INF. 32

Joint Meeting of the RID Safety Committee and the
Working Party on the Transport of Dangerous Goods
(Bern, 18 – 22 March 2002)

Sub-section 6.1.6.2: New list of substances

**Proposal in connection with document OCTI/RID/GT-III/2002/1 (TRANS/WP.15/AC.1/2002/1)
Transmitted by Germany**

Figure 1: Diagram for the assignment of substances to standard liquids
(serves for support of the user; the wording of the paragraphs 6.1.6.2.1 to 6.1.6.2.5 has precedence in case of doubt)

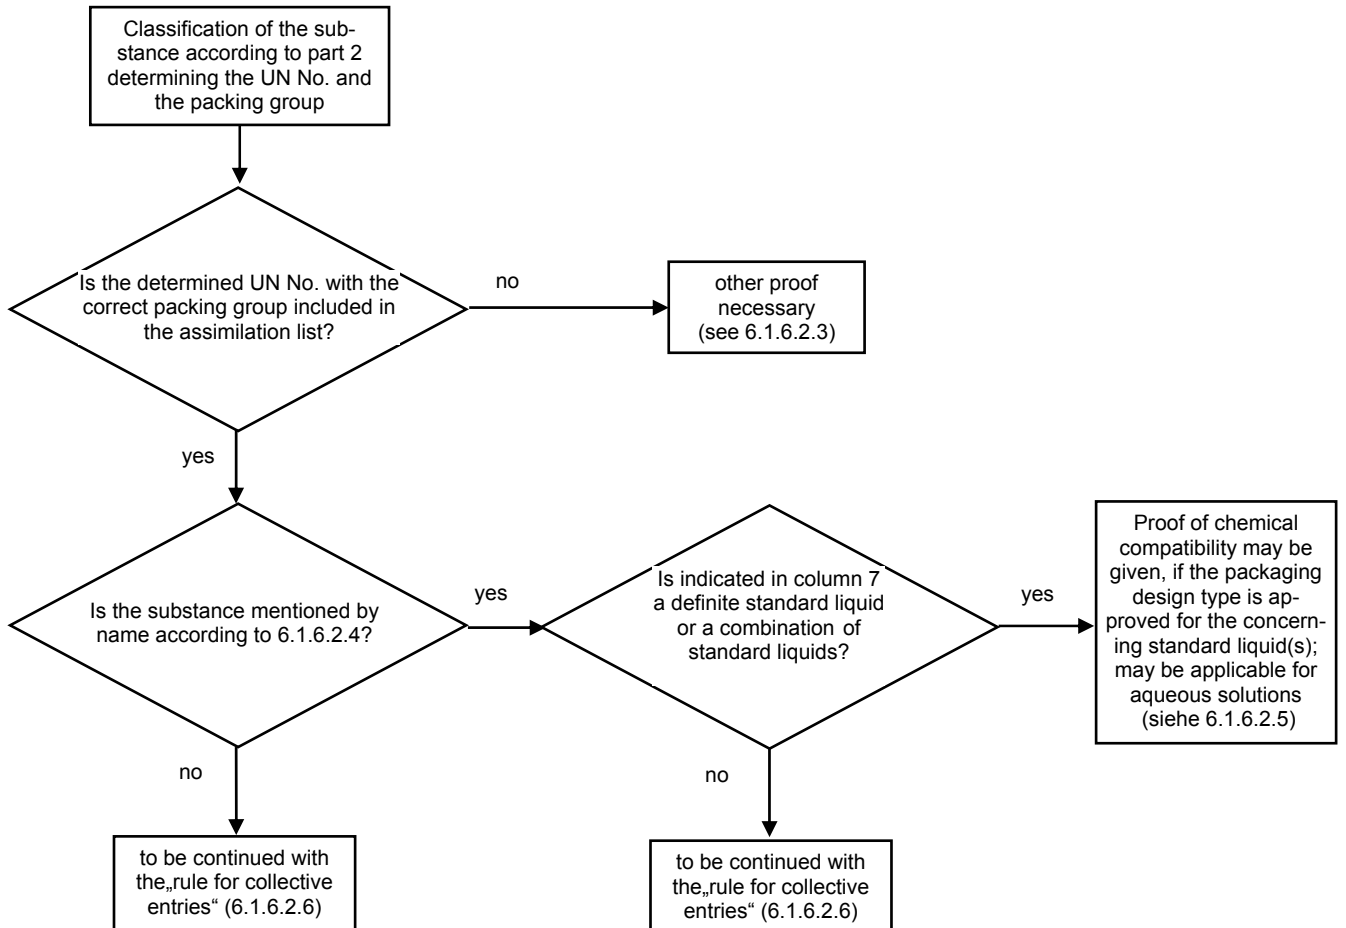
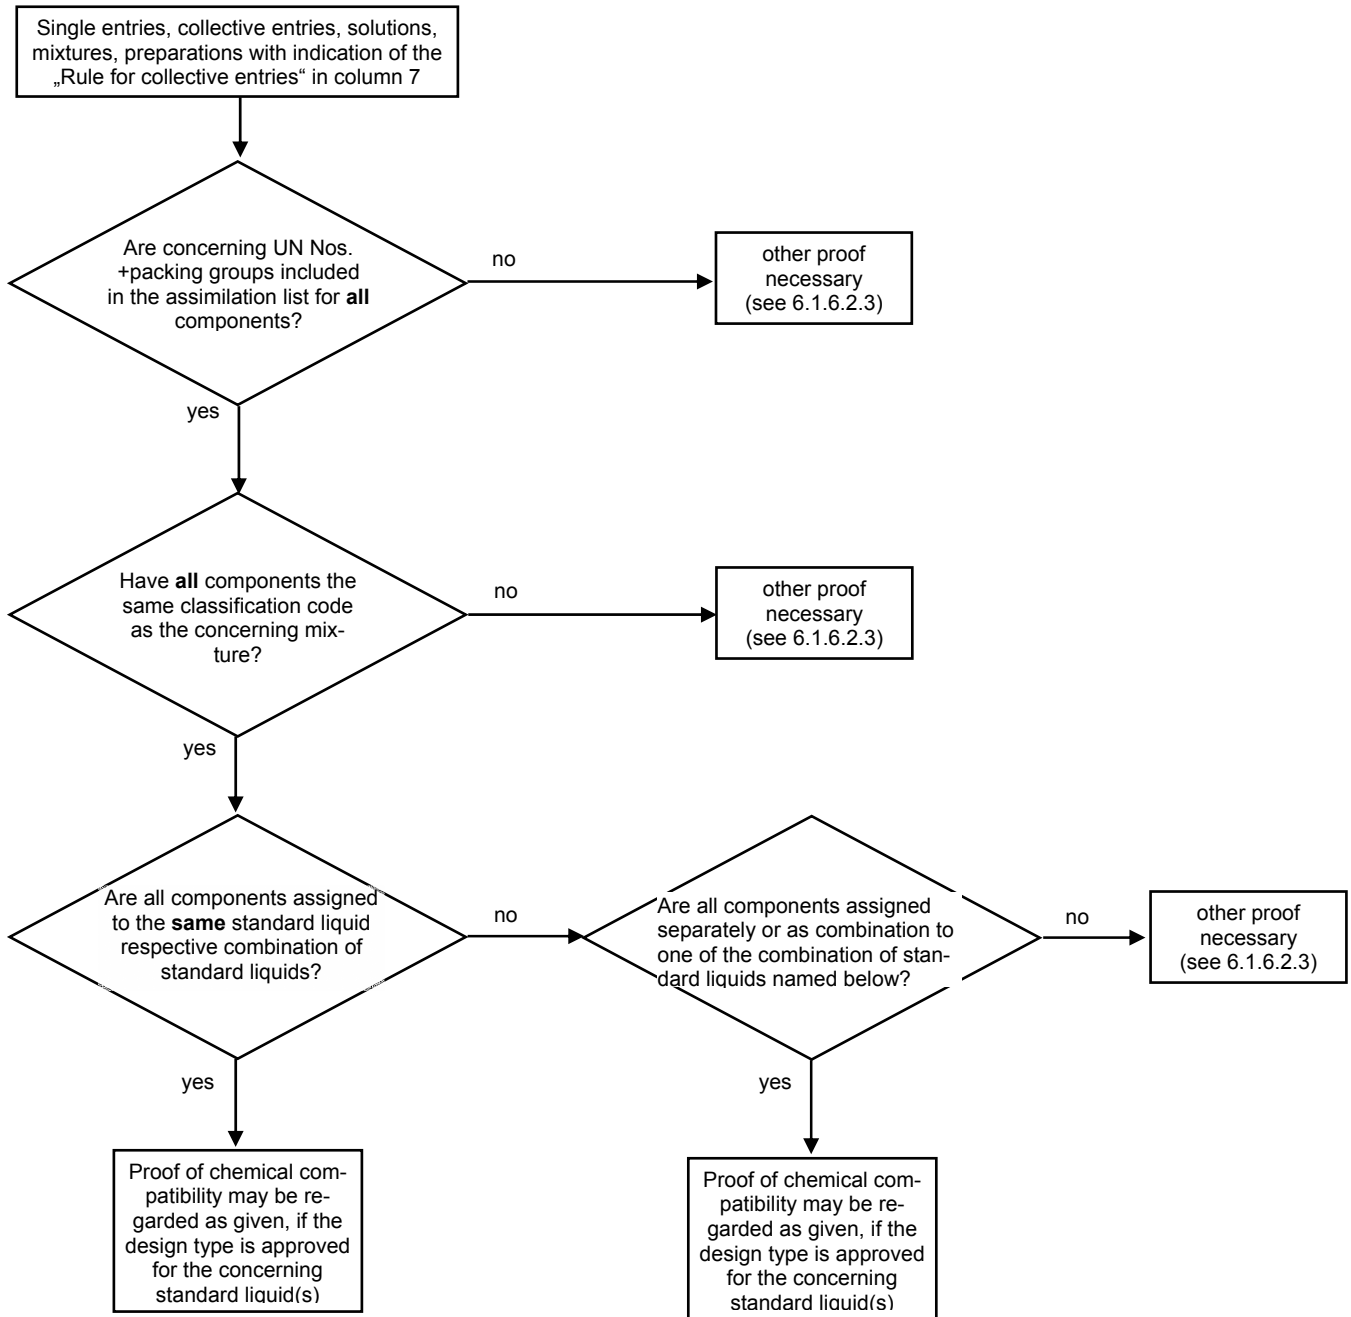
For the assimilation of listed substances and groups of substances mentioned by name the following steps shall be made (see also the concerning simplified diagram of the assimilation procedure in 6.1.6.2.7 **figure 1**):

For the assimilation following steps shall be made (see also the concerning simplified diagram of the assimilation procedure in 6.1.6.2.7 **figure 2**):
